#### FINAL SUPPLEMENT

FINAL ENVIRONMENTAL STATEMENT

Application by Chicago Bridge & Iron Company for Permit to Dredge and Construct a Pier and Dolphins in the Colleton River at Victoria Bluff, Beaufort County, South Carolina

APPENDIX A

- Drawdown generated in potentiometric surface of the Ocalla aquifer by a constant withdrawal of 30,000 gpd at Victoria Bluff, South Carolina. Exhibit 1

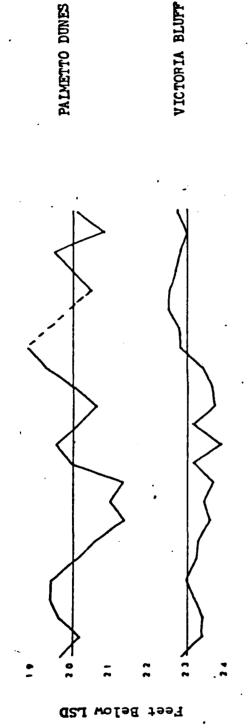
Exhibit 1 is based on the unlikely assumption that there is no leakage of water through the confining bed to replace the water removed by pumpage, that no recharge or discharge barriers are encountered, that natural recharge and discharge are unchanged, and that the aquifer is isotropic and homogeneous. If there were leakage or a recharge barrier, the drawdown, as indicated in Exhibit 1, would be less and at some distance from the pumped well and at some point in time would be zero. As possible evidence for leakage it should be noted that although ground-water withdrawals have increased rapidly at Hilton Head Island during the past few years (estimated average daily withdrawal is 15-20 million gpd), the average yearly potentiometric surface
